Intel[®] Pentium[®] III Processor Specification Update

Release Date: February 2005

Document Number: 244453-052

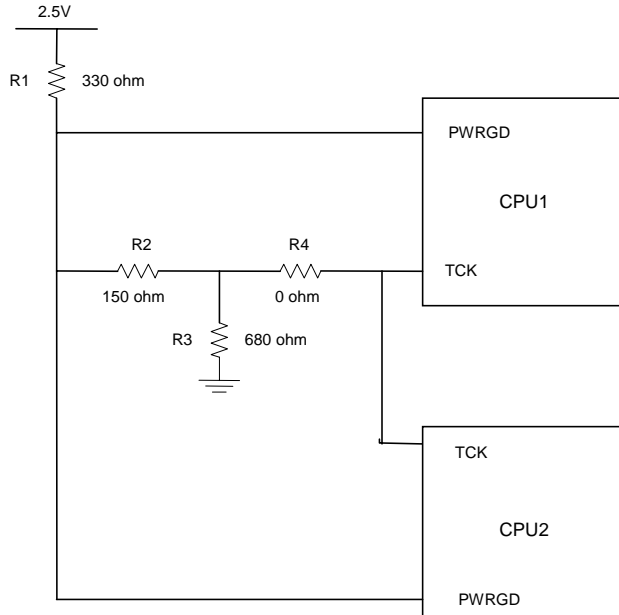
Problem: The internal control register bit responsible for operation of the Thermtrip circuit functionality may power up in a non-initialized state. As a result, THERMTRIP# may be incorrectly asserted during de-assertion of RESET# at nominal operating temperatures. When THERMTRIP# is asserted as a result of this erratum, the processor may shut down internally and stop execution but in few cases continue to execute.

Implication: This issue can lead to intermittent system power-on boot failures. The occurrence and repeatability of failures is system dependent, however all systems and processors are susceptible to failure. In addition, the processor may fail to stop execution during the event of a valid THERMTRIP# assertion resulting in the potential for permanent processor damage.

Workaround: To prevent the risk of power-on boot failures or catastrophic thermal failures, a platform workaround is required. The system must provide a rising edge on the TCK signal during the power-on sequence that meets all of the following requirements:

- Rising edge occurs after Vcc_core is valid and stable
- Rising edge occurs before or at the de-assertion of RESET#
- Rising edge occurs after all Vref input signals are at valid voltage levels
- TCK input meets the Vih min and max spec as mentioned in EMTS
